ADDENDUM NO. 02

November 14, 2025

To Drawings and Specifications dated October 24, 2025

Reynolds Elementary School Maintenance Improvements
Spring Independent School District

ELECTRICAL SITE
PLAN

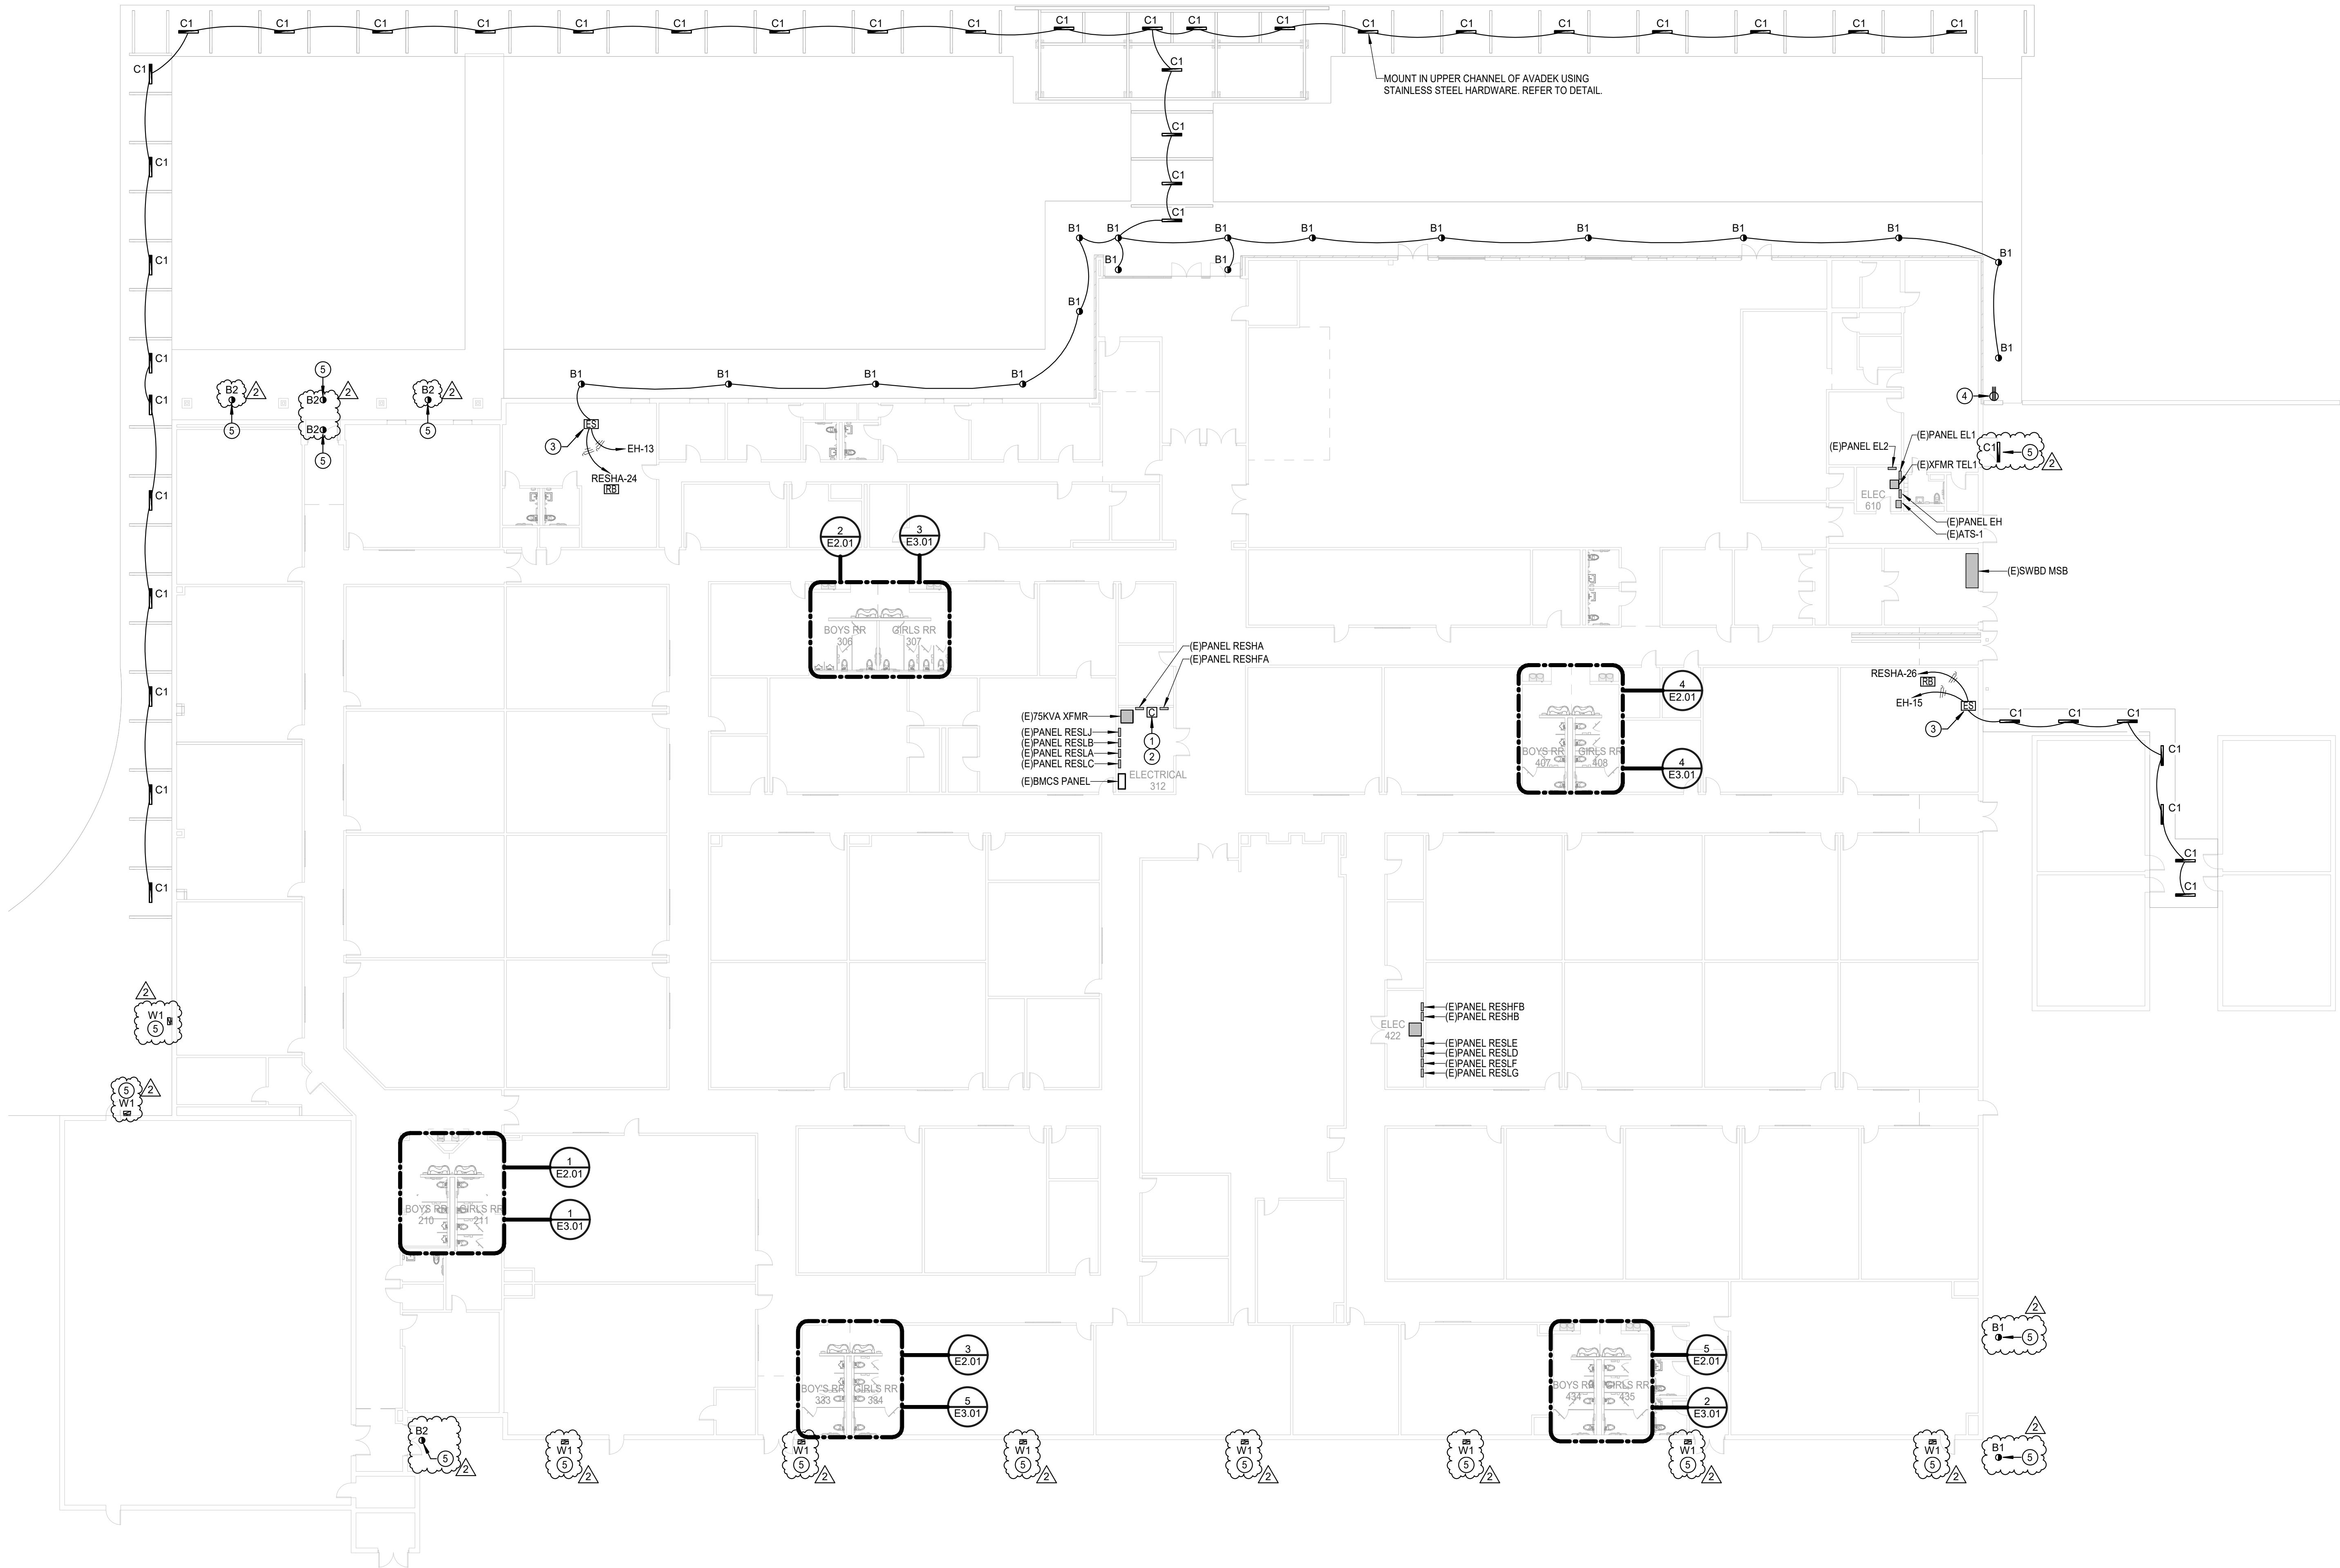
d. Revise exterior canopy light fixture demolition, typical of 8.
 e. Revise exterior wall mounted light fixture demolition, typical of 11.
- Item No. 16 Sheet E0.02, Electrical Site Plan

1. Discard and replace sheet in its entirety.
 2. Revise light pole/base locations and underground conduit.
 3. Add footcandle requirements at residential property line.

4. Revise Site Lighting Fixture Schedule, delete motion sensor from all fixtures.
- Item No. 17 Sheet E1.01, Electrical Composite Plan
 a. Discard and replace sheet in its entirety.
